State of California – Natural Resources Agency
DEPARTMENT OF FISH AND WILDLIFE
Central Region
1234 East Shaw Avenue
Fresno, California 93710
(559) 243-4005
www.wildlife.ca.gov

June 9, 2021

**Subject: California High-Speed Rail Project, San Jose to Merced Section (Project)
Revised Draft Environmental Impact Report/Supplemental Draft
Environmental Impact Study (RDEIR/SDEIS)
SCH No. 2009022083**

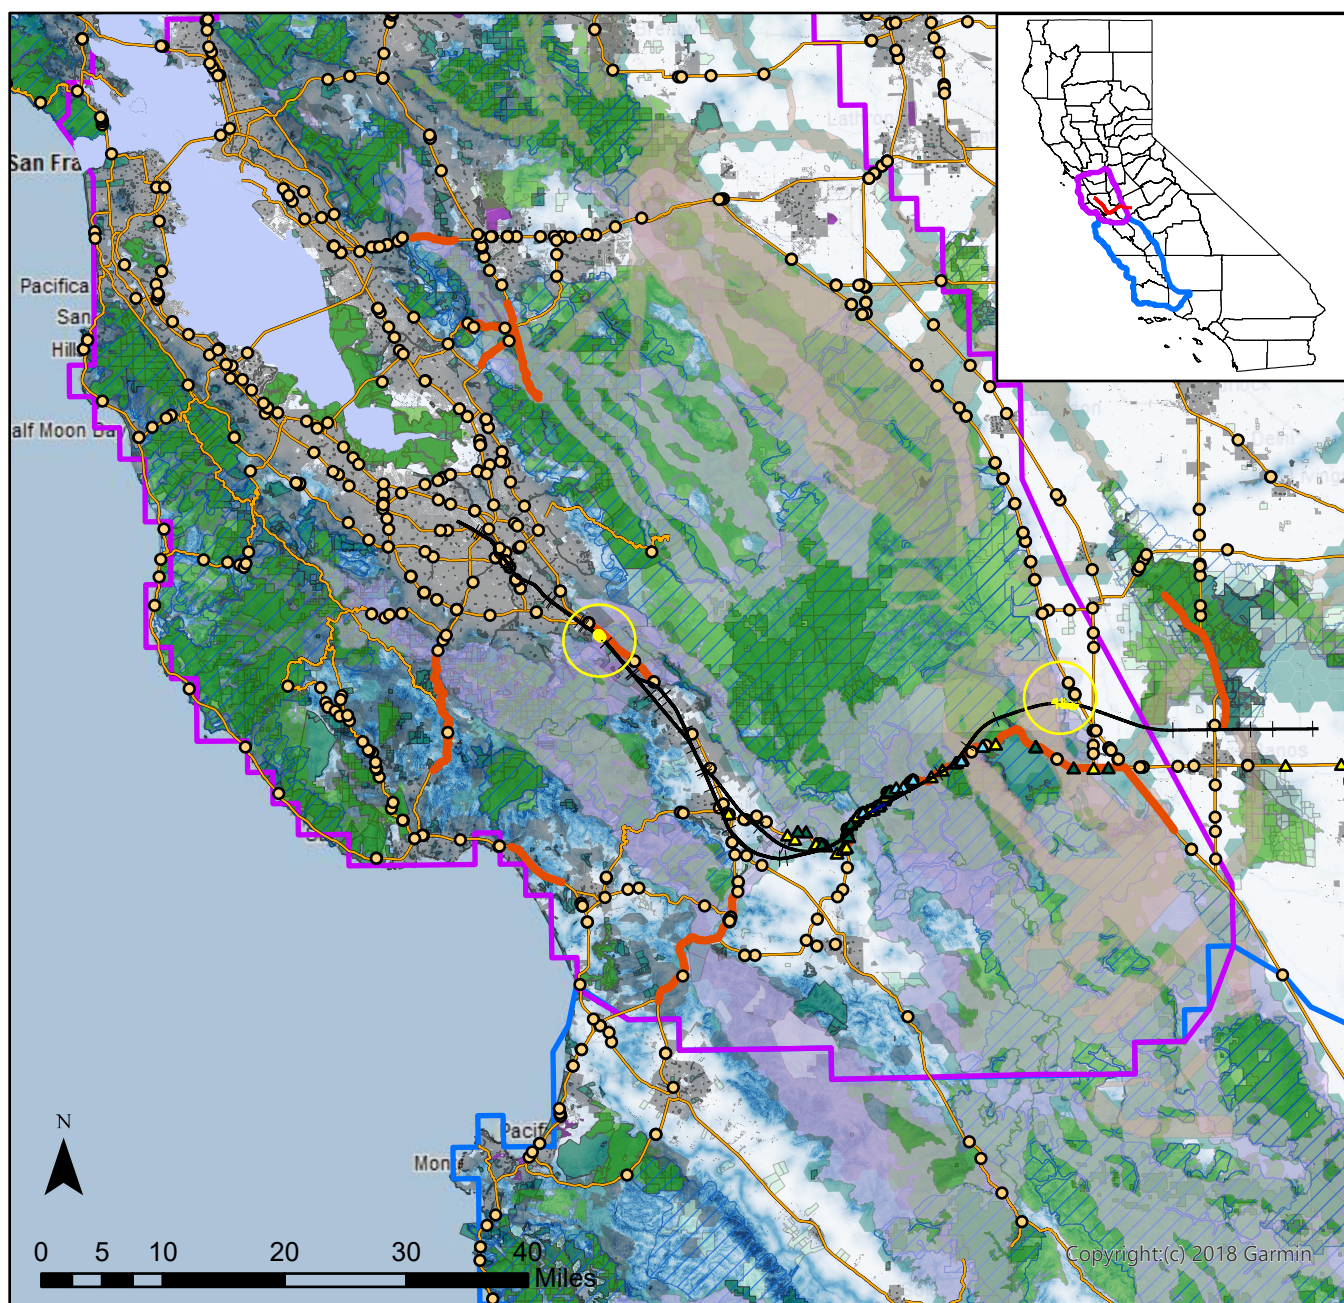
crossing structures) to facilitate unimpeded wildlife movement and gene flow between adjacent areas. CDFW recommends the replacement habitat be located adjacent to the Project and Wildlife Linkage and Corridor, as depicted in Attachment 1.

Figure 3.7-D-2 is missing the CC-N and CC-C ESUs and does not depict areas of connectivity. CDFW has provided Attachment 1 for the Authority to reference mapping of the subpopulation locations.
